REMARKS

Claims 1-14 are currently pending in the application. The Examiner's indication that all of the claims would be allowable if rewritten to overcome the rejections under 35 USC § 112 second paragraph is acknowledged with appreciation.

ANNOTATED MARKED-UP DRAWINGS

FIG. -11-

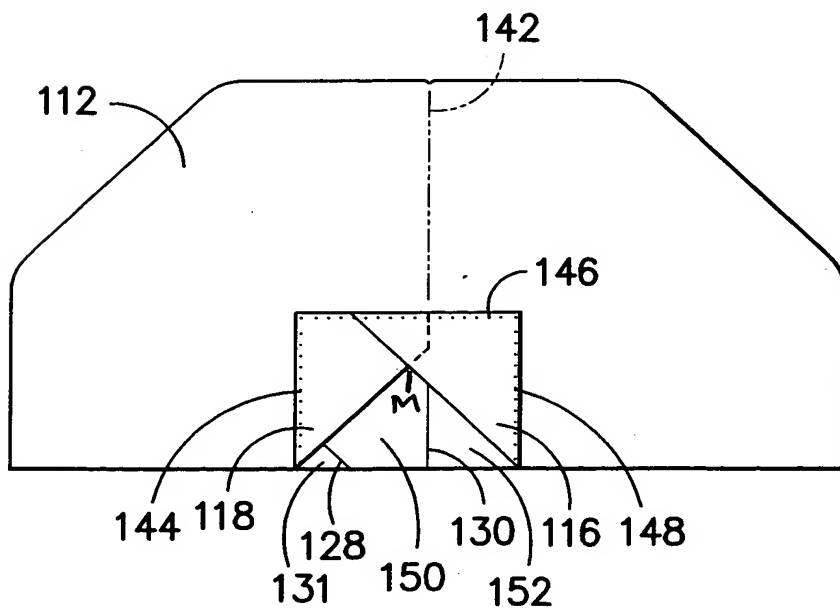
- B. On page 16, lines 7-9 were indicated as not being accurate relative to the drawing. Specifically, line 142 was indicated as not being illustrated as being off-center. That paragraph has been amended to clarify that the foldline is offset relative to the center of the mouth, and a proposed drawing correction to FIG. 11 to add a reference numeral at the center of the mouth has been added.

FIG. -25-

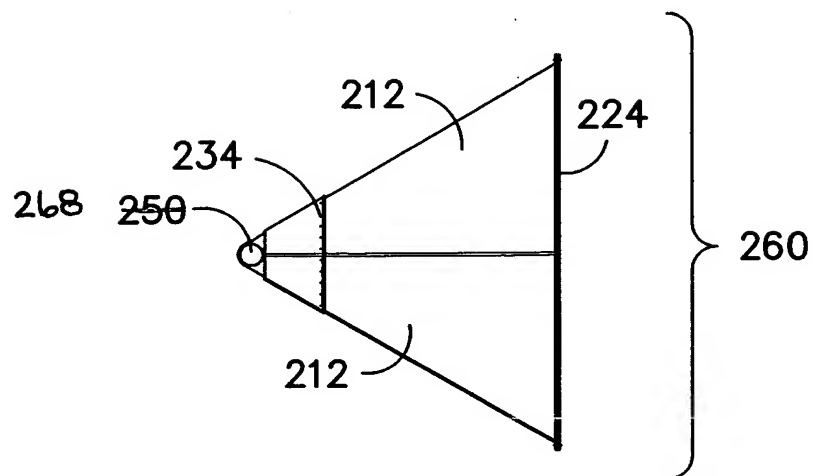
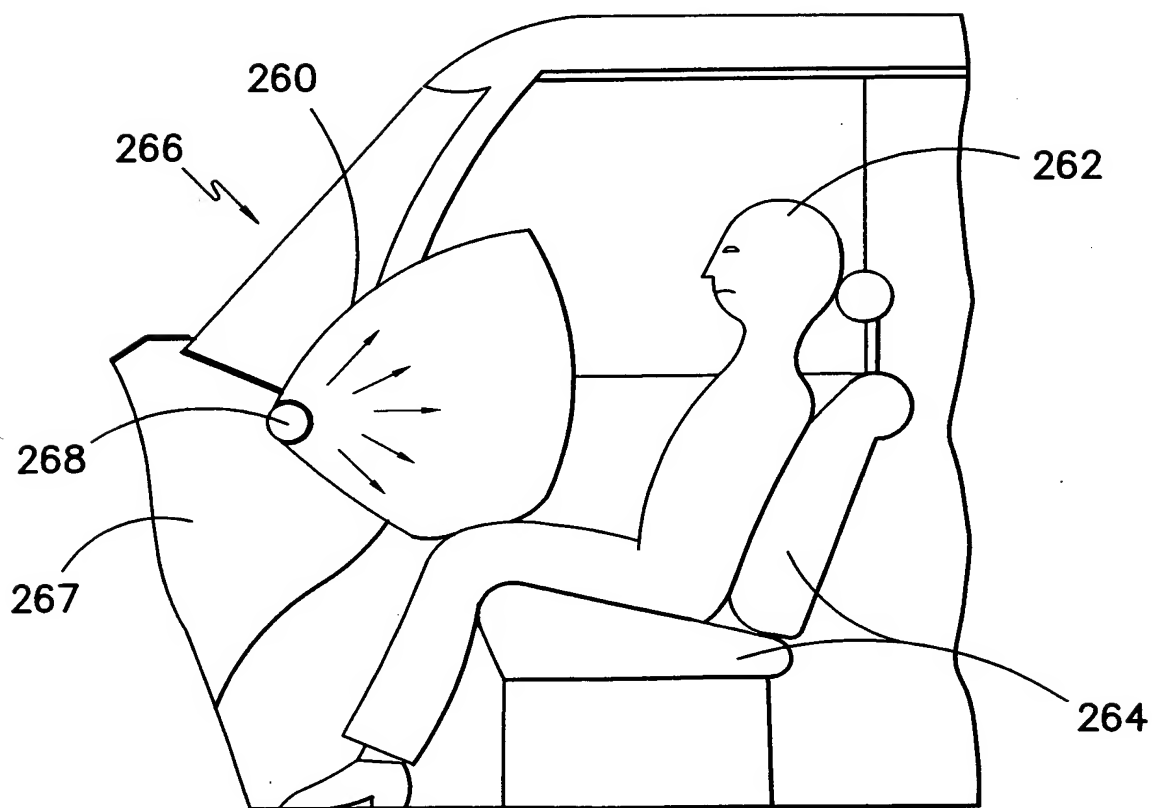
- E. Reference numeral 250 in FIG. 25 was not in the specification. Accordingly, a reference to this figure has not been added to the specification on page 18, line 9. Also, reference numeral 250 in FIG. 25 was indicated as pointing to inflation means, but in FIG. 26, reference numeral 268, was indicated as being inflation means. A proposed drawing correction for FIG. 25 has been submitted herewith changing numeral 250 to numeral 268. Approval of this drawing change respectfully requested.
